# **Planning Delegated Committee Meeting**

## **Agenda**

**13 April 2022 at 6:30pm**

| 6.2. PLP2019/546 Lot 1 Heinz Lane, Invermay Park.....              | 56         |

**3.3 ITEM 3 – SECTION 2 SITE DESCRIPTION – FIGURE 2 – EXTENT OF BERM**

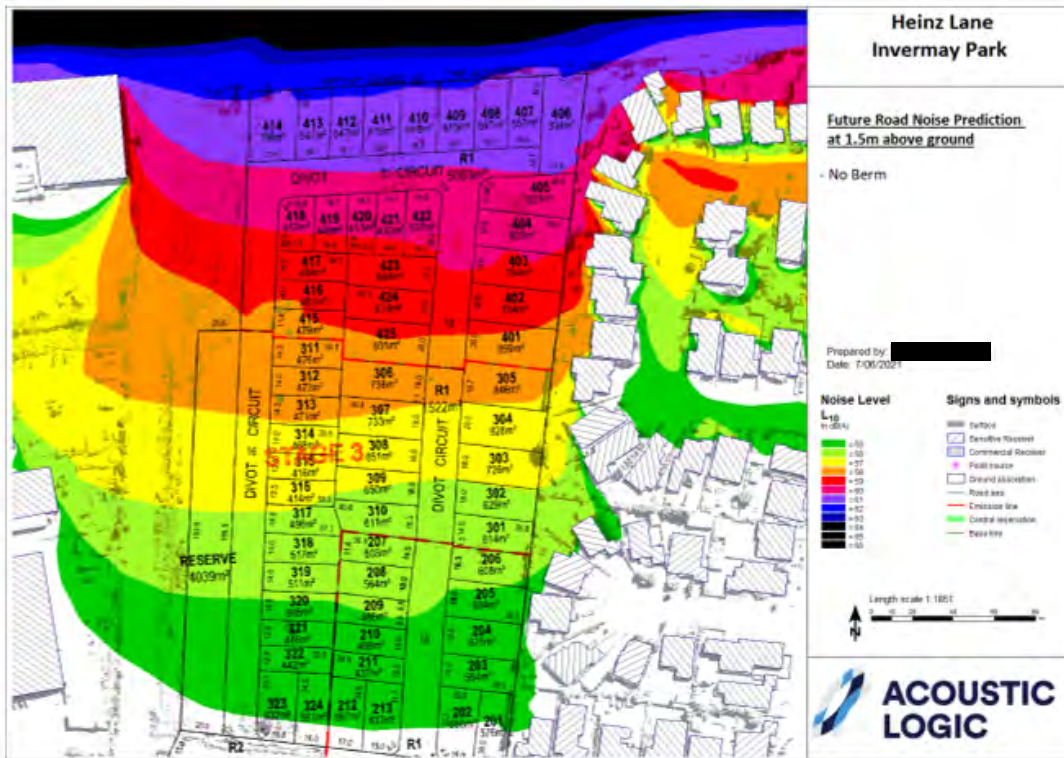
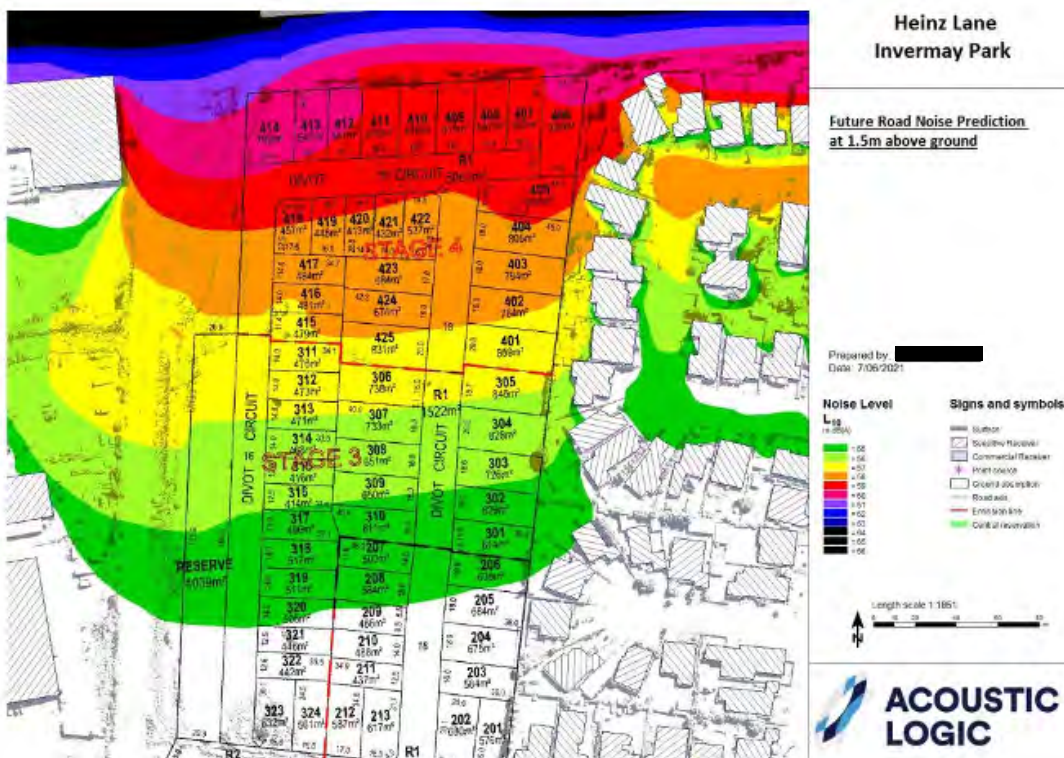
| 3 | Medium | Section 2 Site Description, Figure 2 – Extent of Berm, Page 5 | The extension of the berm is not explained in the report. It is assumed that this will assist to mitigate the propagation of traffic noise across the site? What degree of noise mitigation does the berm provide? |

Appendix 1 presents detailed information on the proposed berm. The following comments are provided

1. The berm will be a natural berm constructed from soil and fill
2. Will be an extension of the existing natural berm located directly to the east.
3. Comparison of noise from vehicle movement on the Western Freeway with and without the berm is presented below.
4. Analysis indicates that construction of the berm will reduce noise levels by approximately 2 dB(A)
